PROJECT Our Town Hall

DRAWING TITLE Princess Street extension
roof NRp01 detail sections
H-H and G-G

DRAWING STATUS S4 Construction

OTH-PUR-TH-RF-DWG-A-7406 04

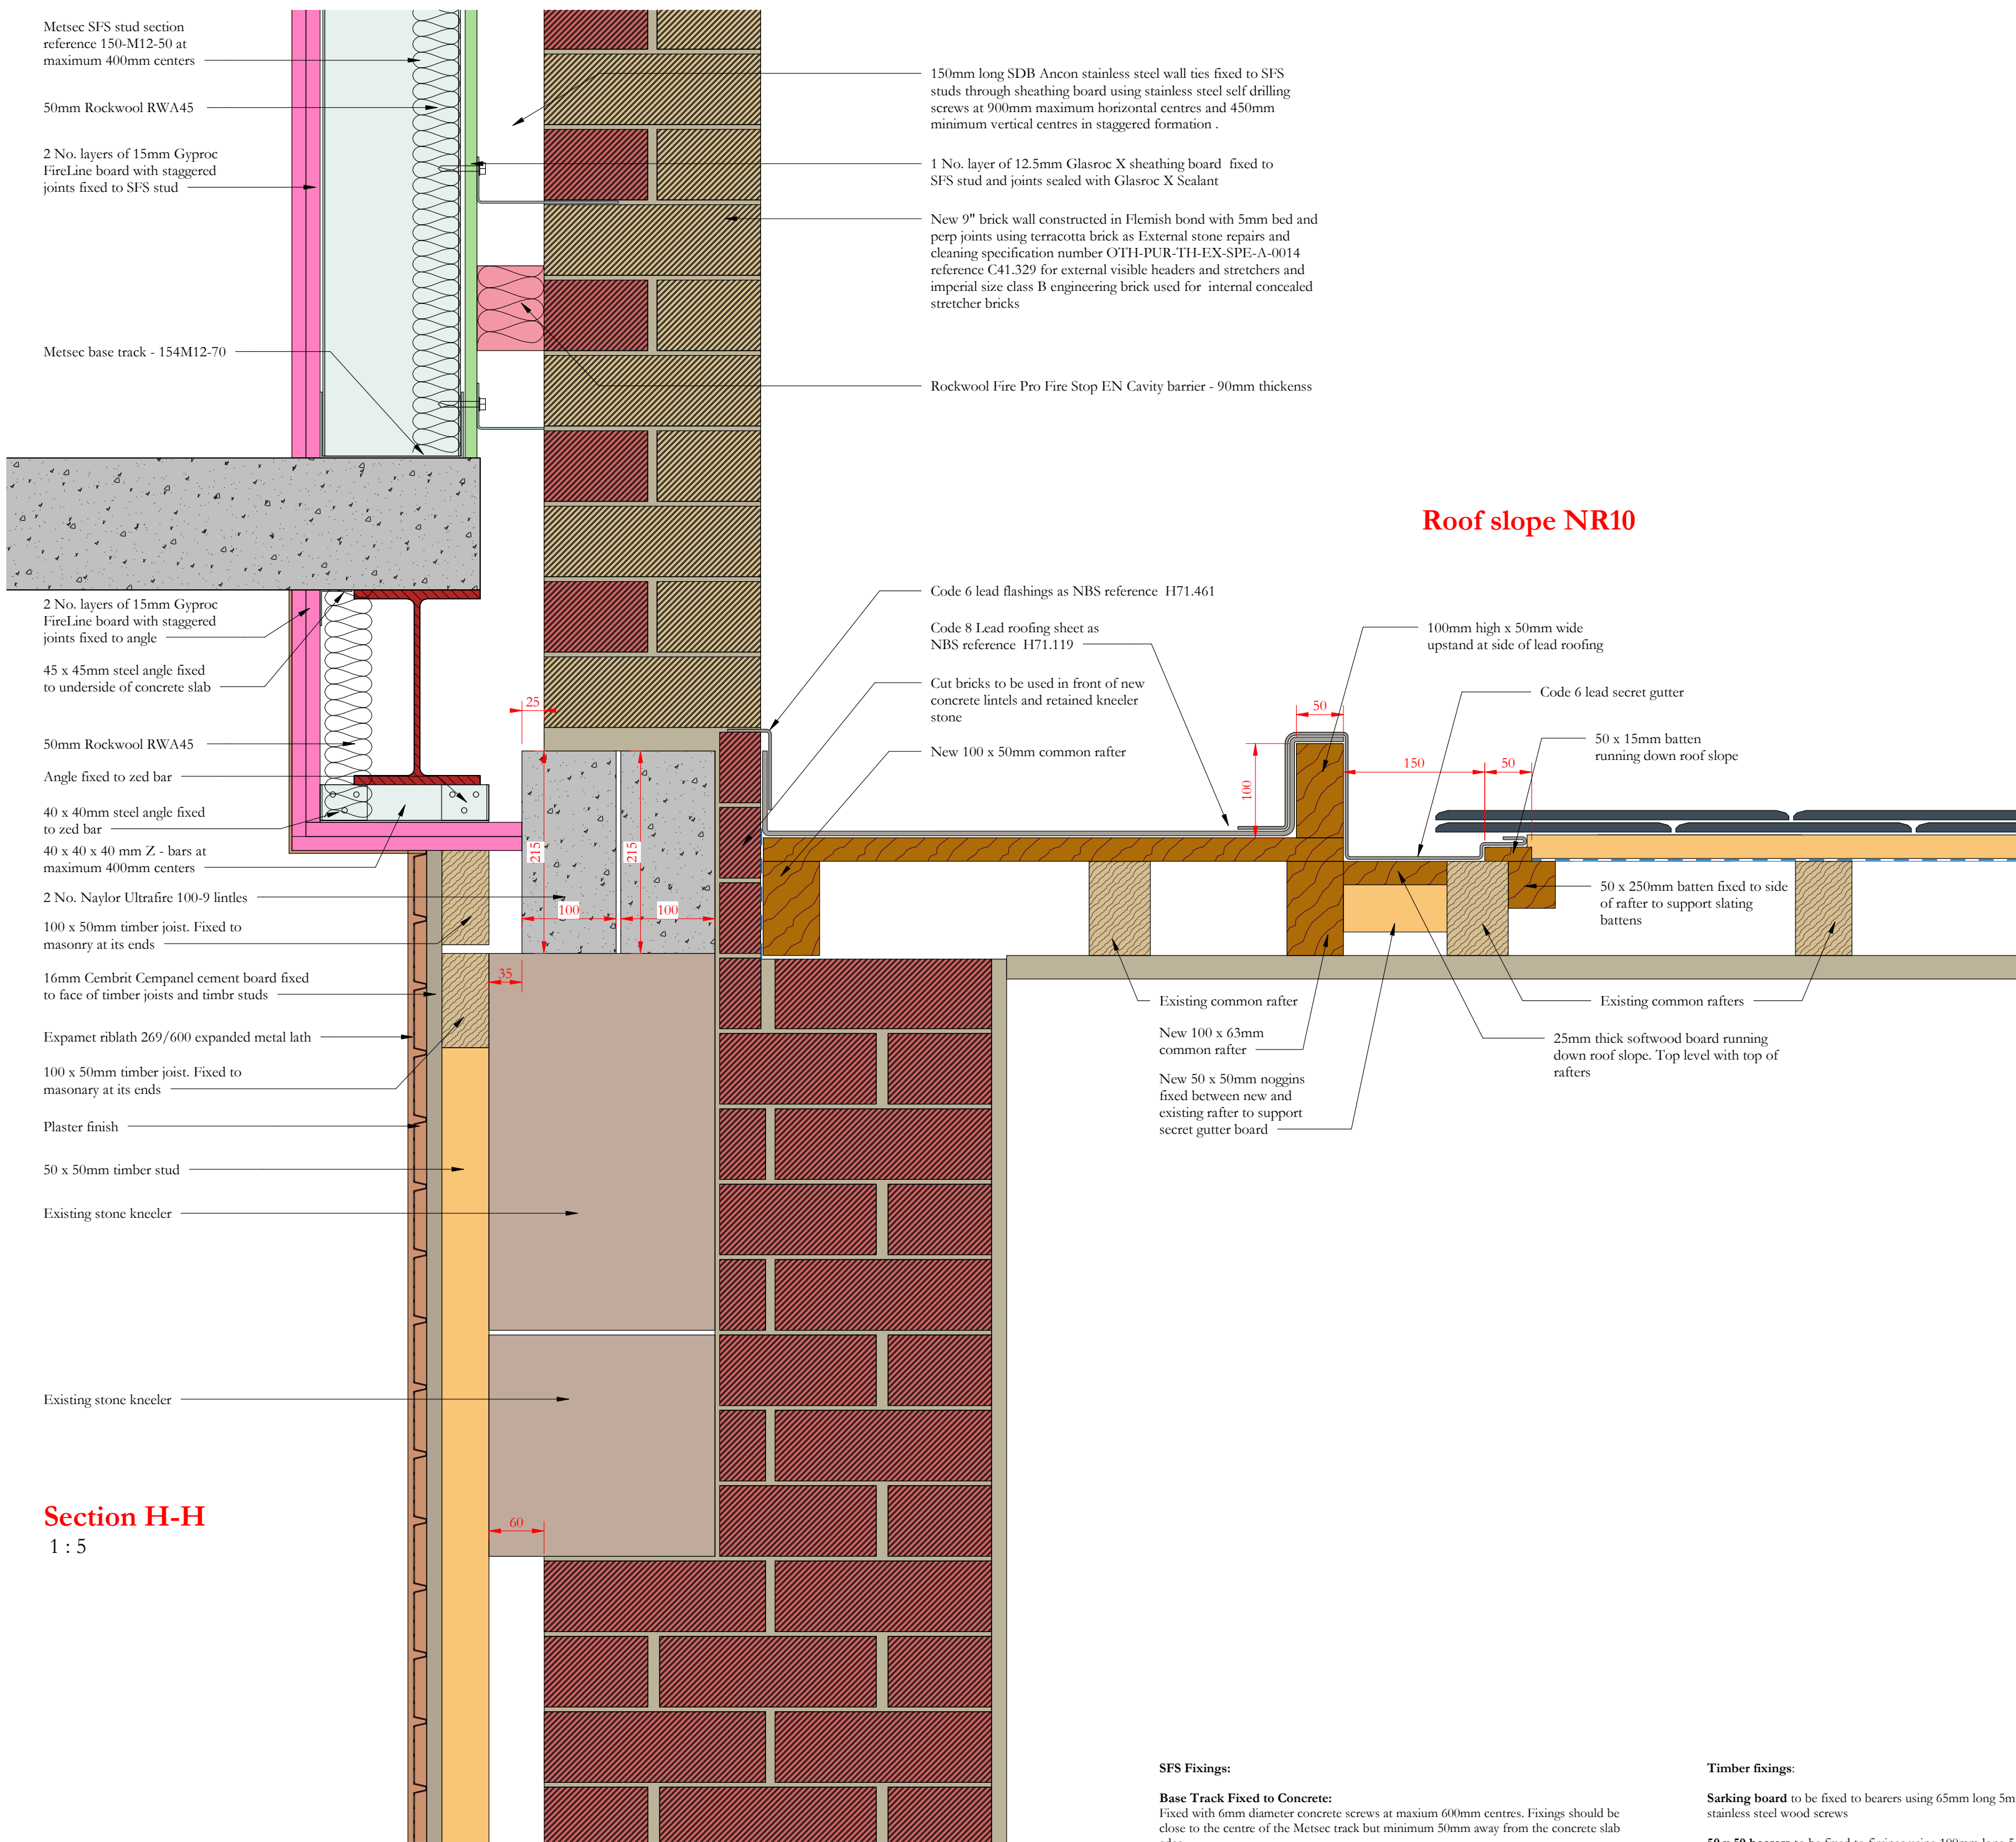
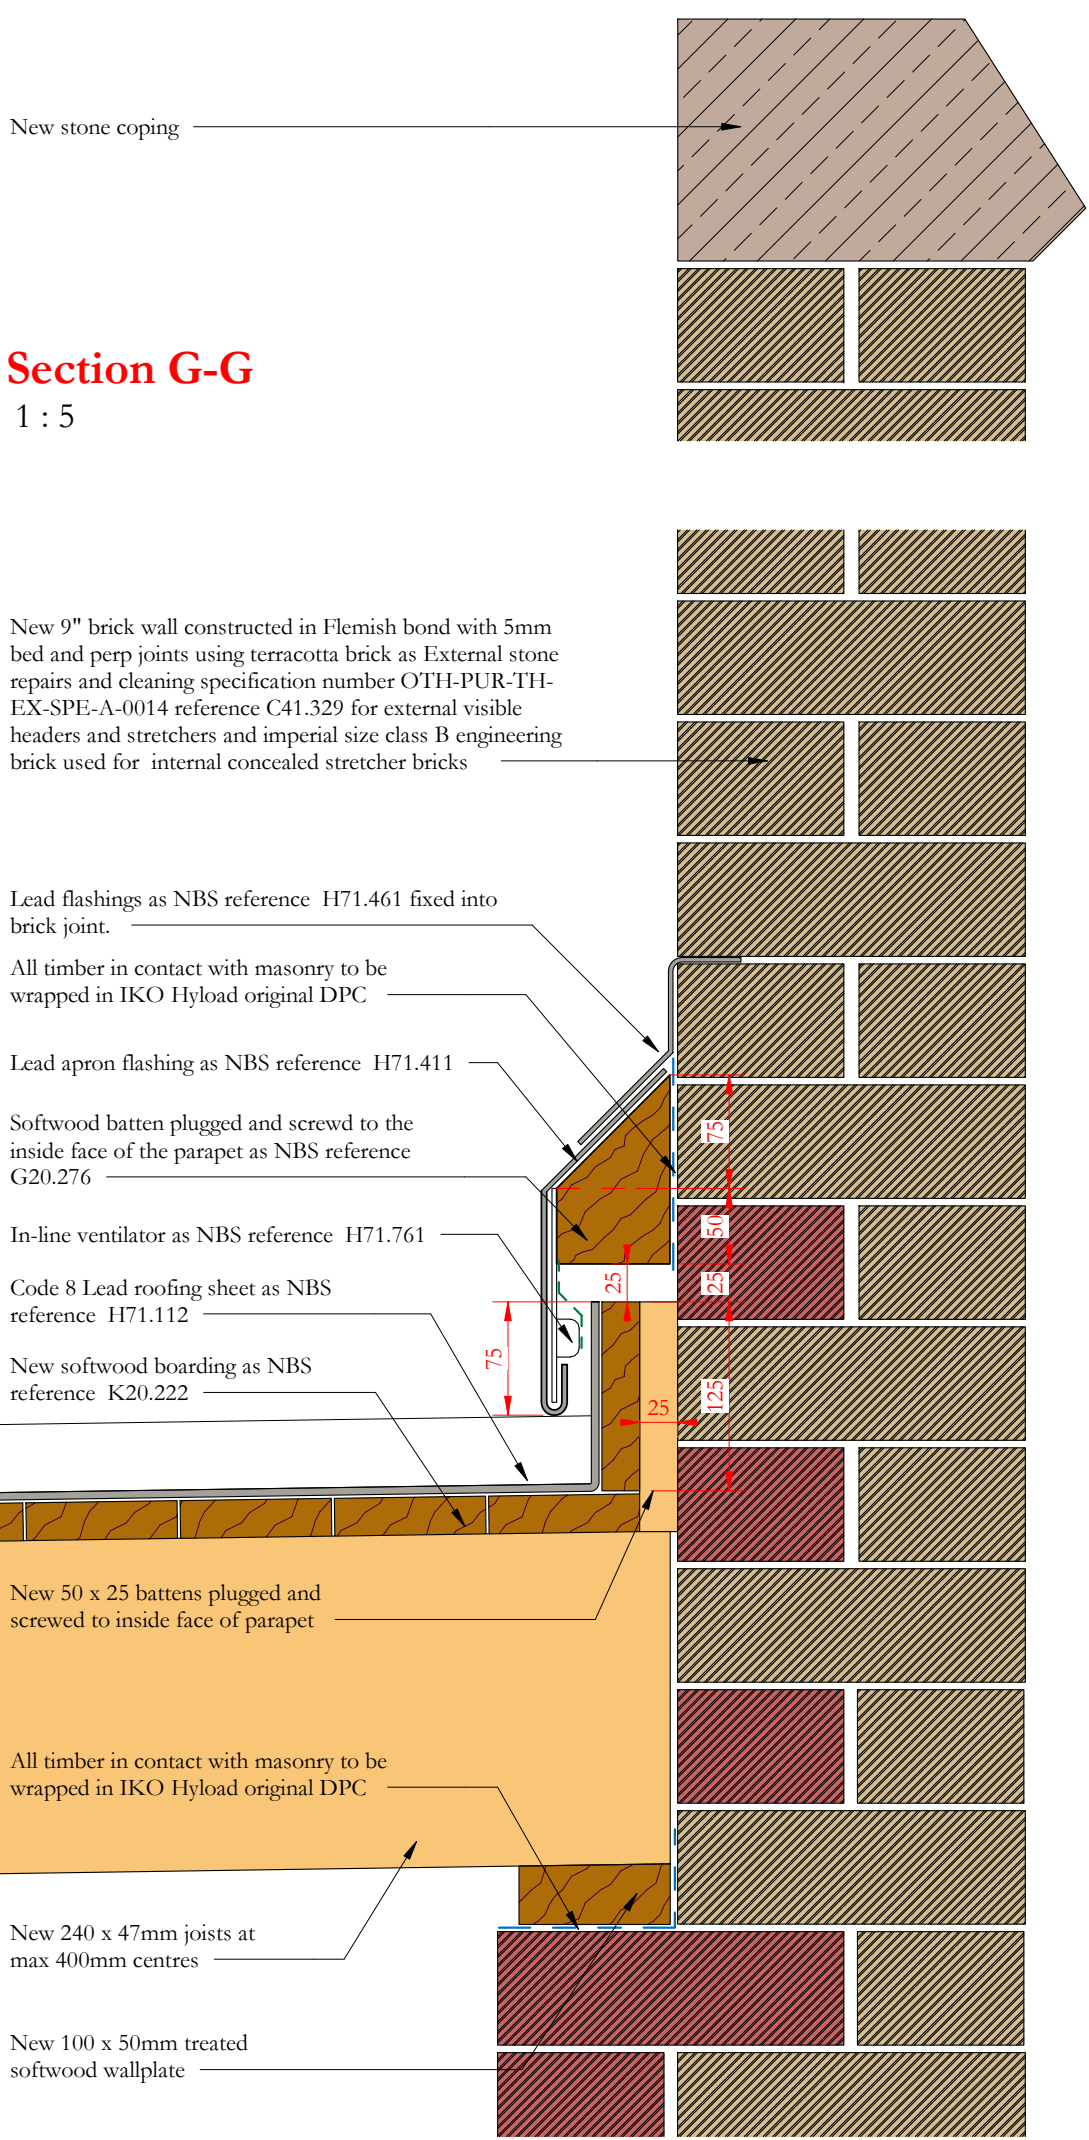
Revision 04: Width of secret gutter increased from 75mm to 150mm.
Timber batten will between lead roofing and secret gutter changed to 100 x 50mm battens

Revision 03: Timber and SFS fixing notes added

Revision 02: Brick tie setting out amended. Encasement detail to steel beam adjacent to wall amended and Rockwool Fire Pro cavity barrier added

Revision 01: Sarking board on cavity face of Metsec framing changed from 2 No. layers of cement board to 1 No. layer of Glasroc X. Internal plasterboard changed from 2 layers of Fireline board to 1 layer of Fireline and 1 layer of Fireline Duplex board. 50mm Rockwool RWA 45 added within Metsec framing zone. Detail around beam above door opening amended to completely encase beam. Plastered boxing detail added to conceal projecting ends of kneeler stones
